**Department of Licensing and Regulatory Affairs**

**Final Report - Resubmittal Requested**

**Application Number: PR2023BCC-001595**

**Description : BLDG23-01596 Renovate Detroit Light Guard Armory**

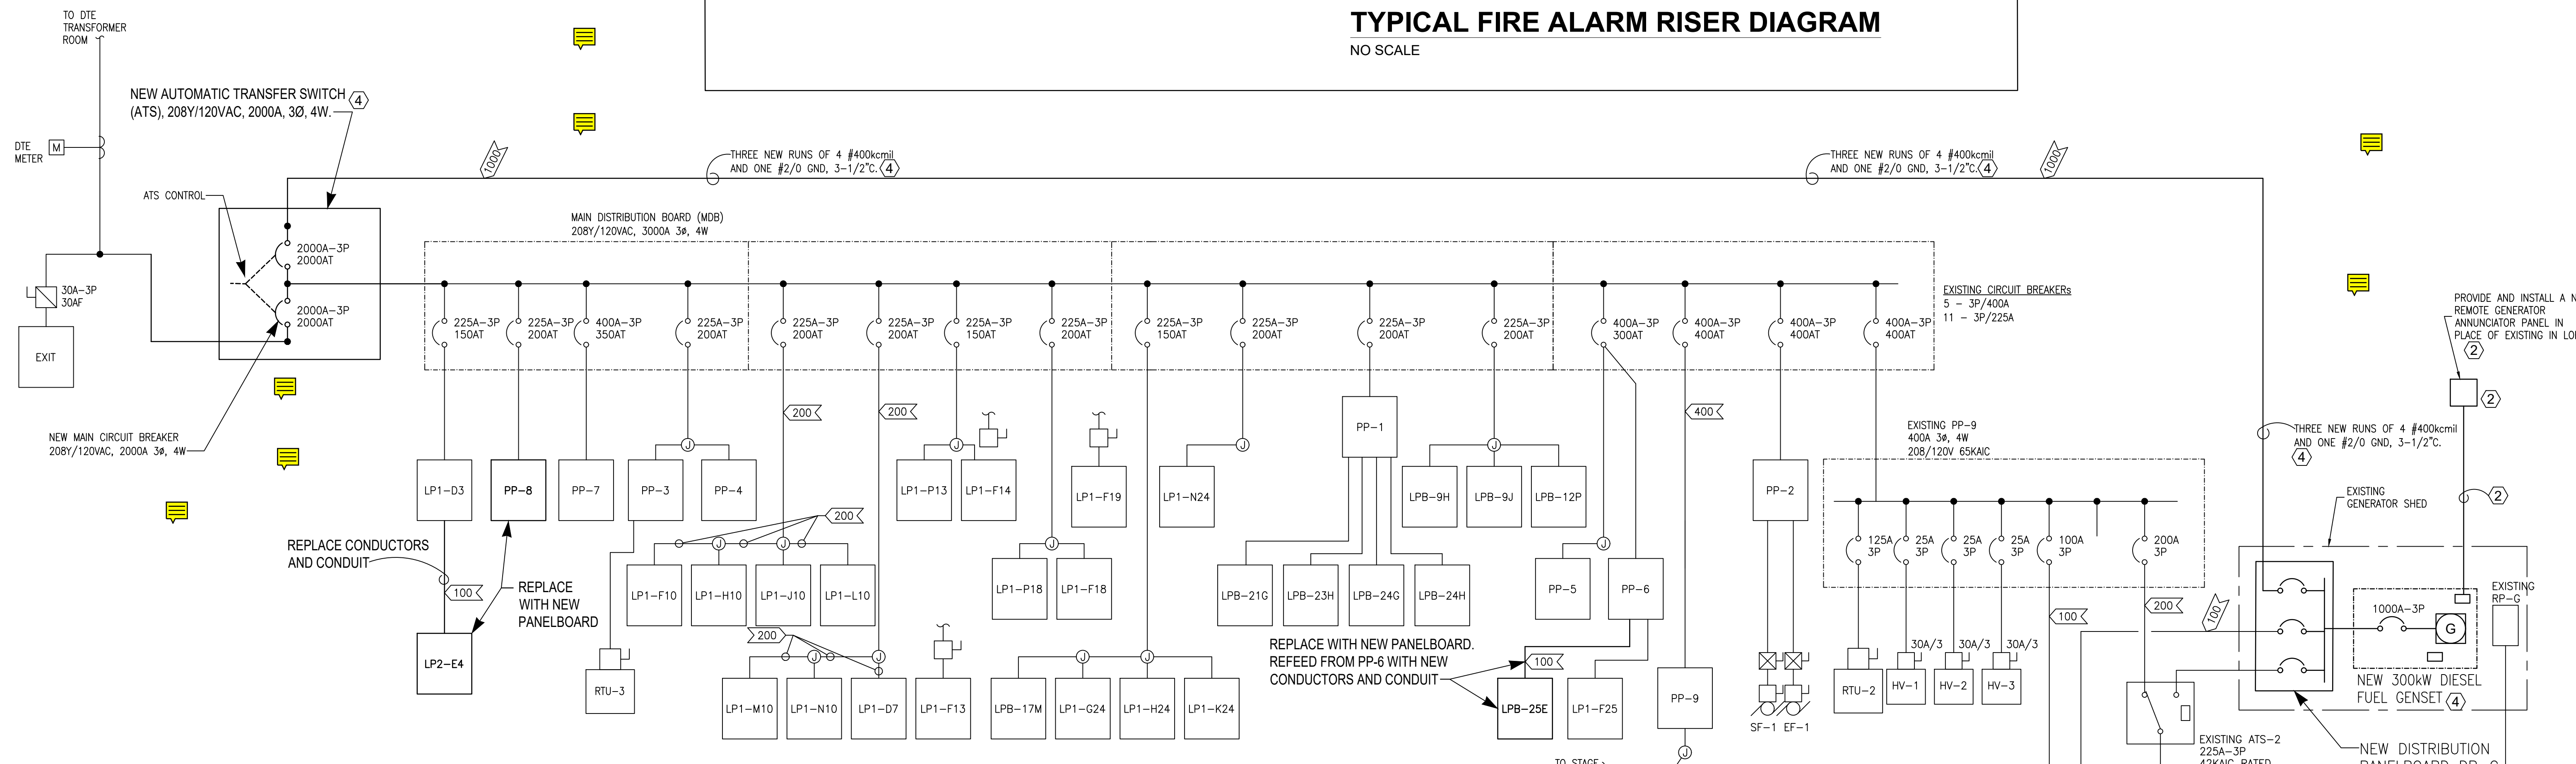
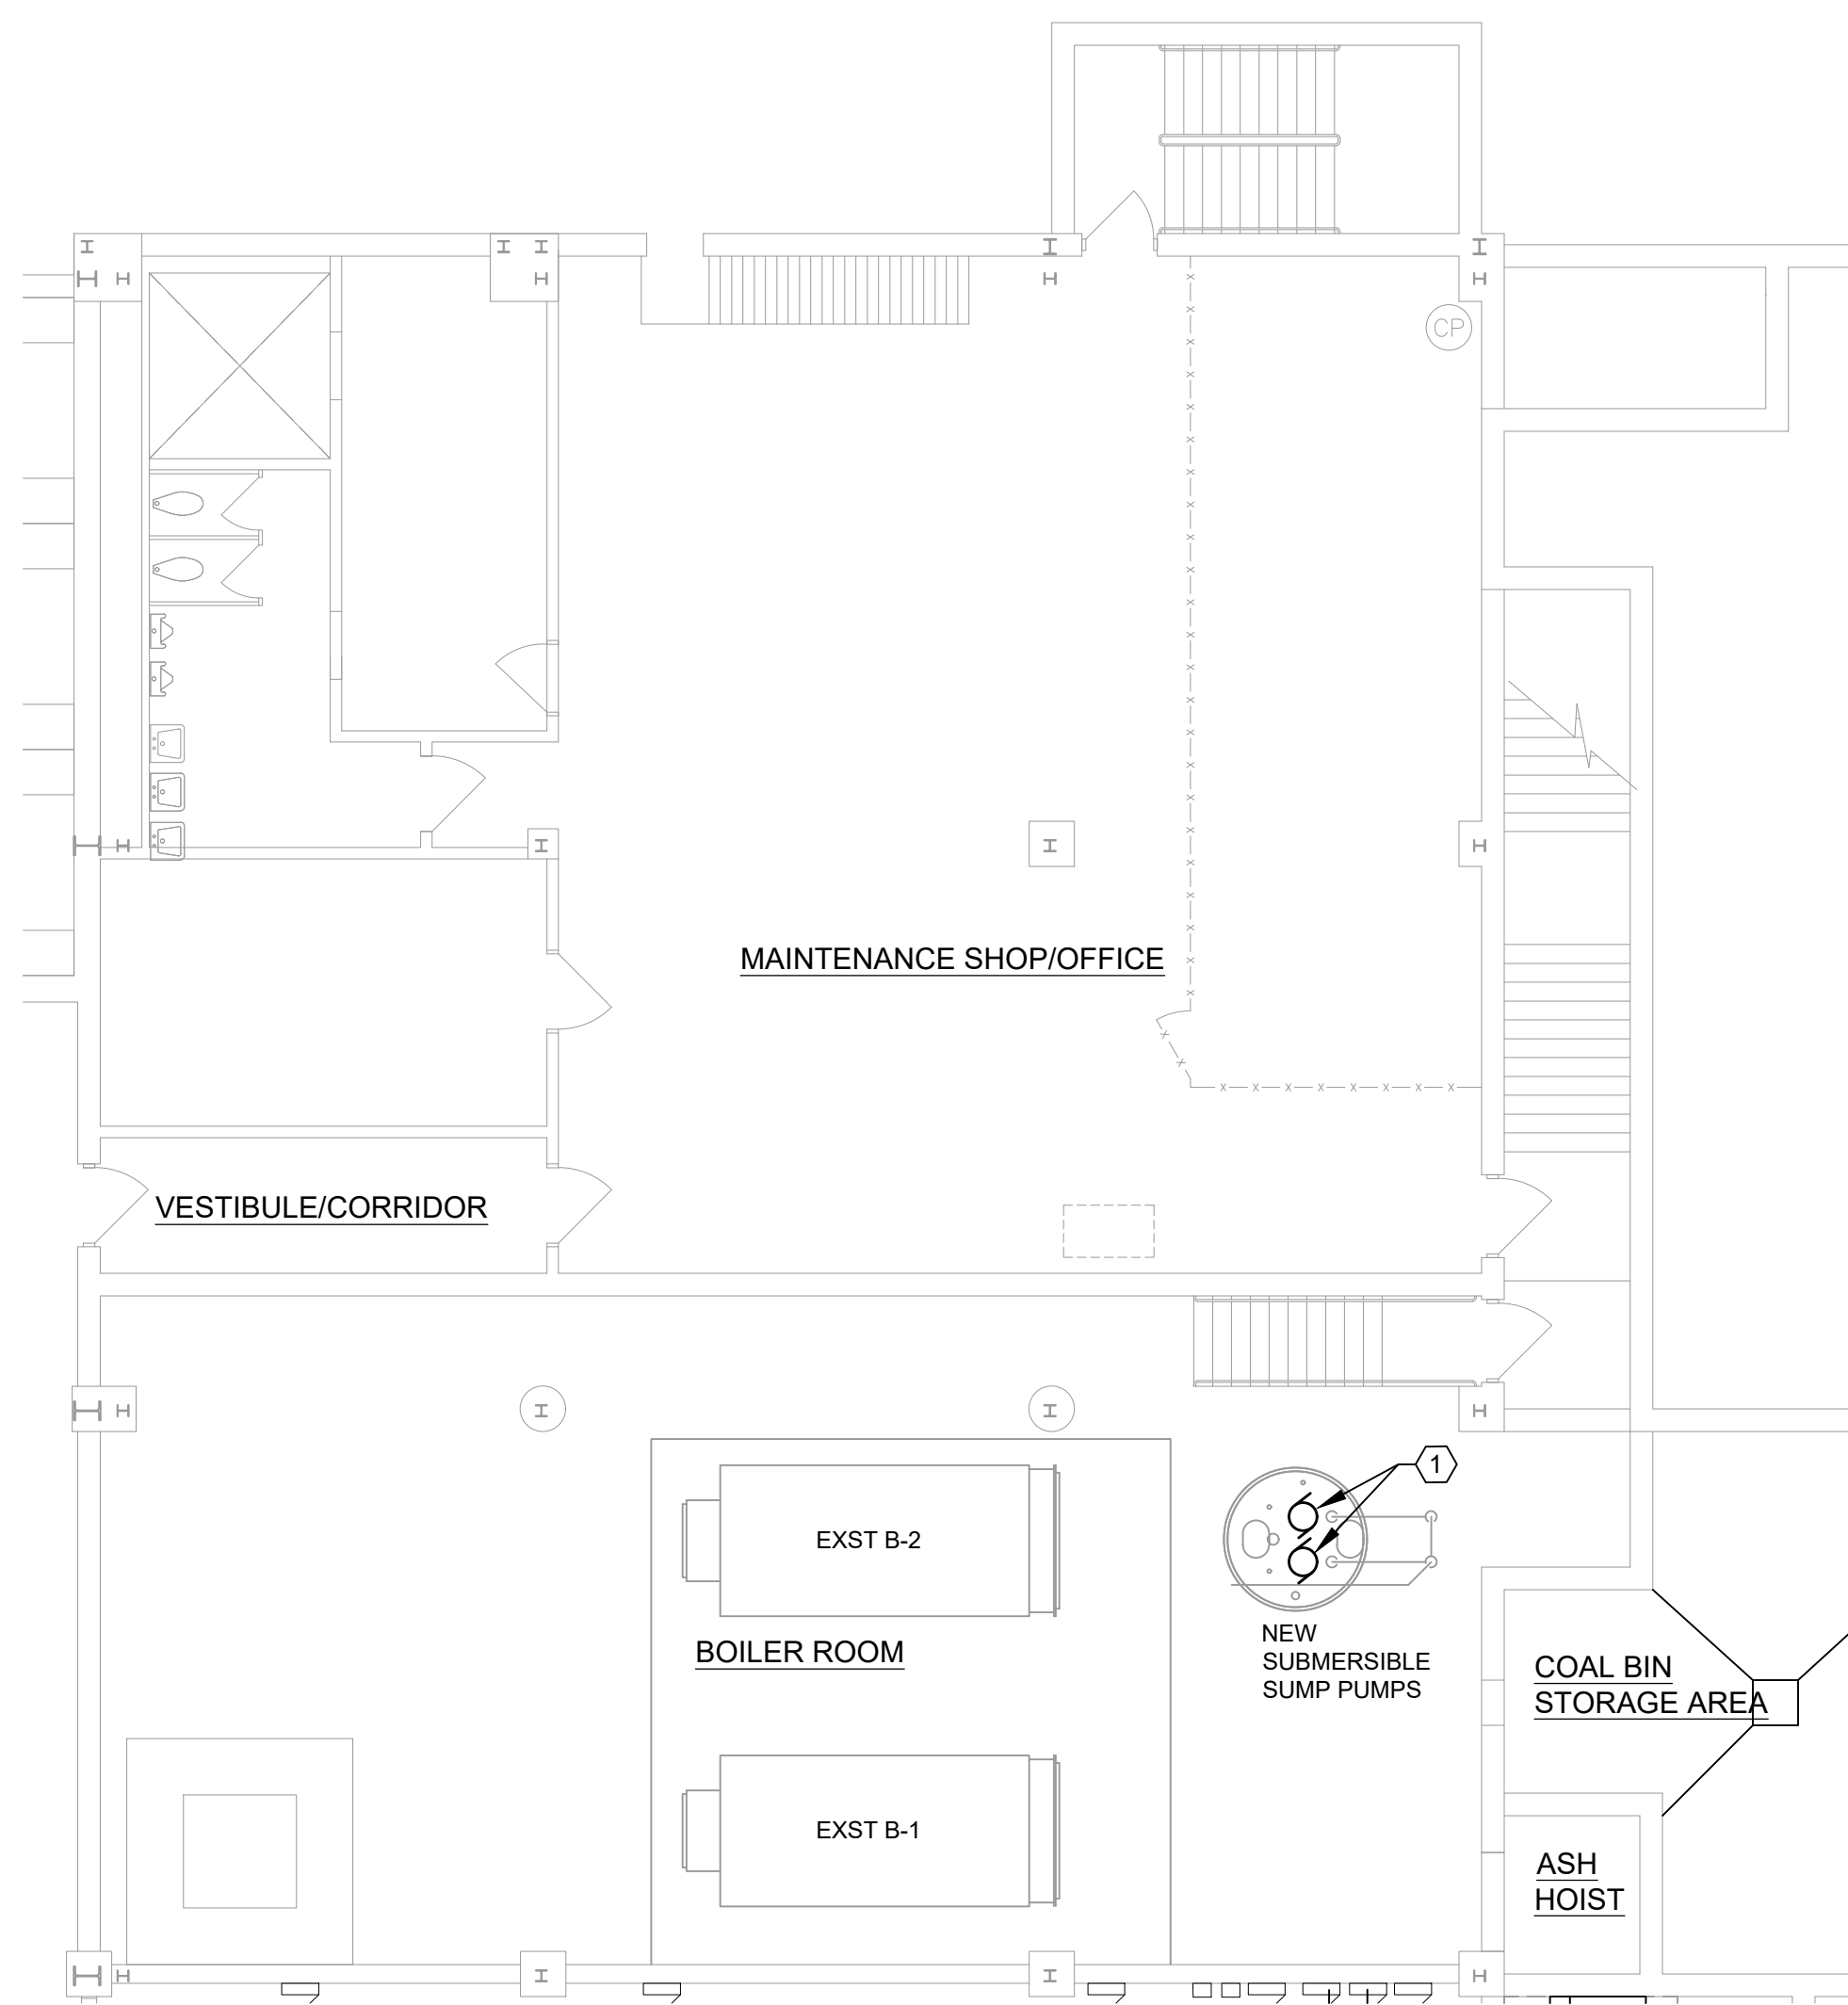
Comment ID	Page Ref	Reviewer : Department	Review Comments
7	E10	Neil Pline : Electrical	NEC, Section 445.18 - Generators other than cord- and plug-connected portable shall have one or more disconnecting means. Each disconnecting means shall simultaneously open all associated ungrounded conductors. Each disconnecting means shall be lockable in the open position in accordance with 110.25. Generators shall have provisions to shut down the prime mover. The means of shutdown shall comply with all of the following: (1) Be equipped with provisions to disable all prime mover start control circuits to render the prime mover incapable of starting. (2) Initiate a shutdown mechanism that requires a mechanical reset. The provisions to shut down the prime mover shall be permitted to satisfy the requirements of 445.18(A) where is it capable of being locked in the open position in accordance with 110.25. Generators with greater than 15 KW rating shall be provided with an additional requirement to shut down the prime mover. This additional shutdown means shall be located outside the equipment room or generator enclosure and shall also meet the requirements of 445.18(B)(1) and (B)(2).

8	E10	Neil Pline : Electrical	NEC, Sections 250.3, 250.4, 250.8, 250.24, 250.50, 250.52, and table 250.66 - Properly sized and type of service grounding electrode conductors are required from the service equipment to all electrodes that are present. Provide a grounding detail with the connection at the ATS. Remove the connection at MDB.
9	E10	Neil Pline : Electrical	NEC, Sections 215.2, Table 310.15(B)(16), and Chapter 9 - Proper number of conductors, size, type and conduit size is required for feeders less than 600 volts. Provide conductor sizes from ATS to MDB.
15	E10	Neil Pline : Electrical	NEC, Sections 110.3(A) and (B) - The wiring method(s) used shall be suitable for the installation and use in conformity with the provisions of the NEC. Listed or labeled equipment shall be used or installed in accordance with any instructions included in the listing or labeling. The installation of the ATS to MDB shall not void the listing and labeling of that equipment.

16	E10	Neil Pline : Electrical	Part 8 Rules, Section 80.21 - Diagrams of feeders are required showing demand loads, connected loads, demand factors used, and load calculations for each panel individually and the total service. Provide existing load calculation for the total service of MDP.
17	E10	Neil Pline : Electrical	Electrical plan review will proceed when all discrepancies are addressed on signed and seal construction drawings.
10	E12	Neil Pline : Electrical	NEC, Article 515 - Bulk storage plants shall comply with code requirements for hazardous location wiring methods. Seal-offs are required on all conduits.
11	M2	Daniel Morris : Mechanical	MMC, Section 1011.1 - Tests. Upon completion of the assembly and installation of boilers and pressure vessels, acceptance tests shall be conducted in accordance with the requirements of the ASME Boiler and Pressure Vessel Code or the manufacturer's requirements, and such tests shall be approved. A copy of all test documents along with all manufacturer's data reports required by the ASME Boiler and Pressure Vessel Code shall be submitted to the code official.
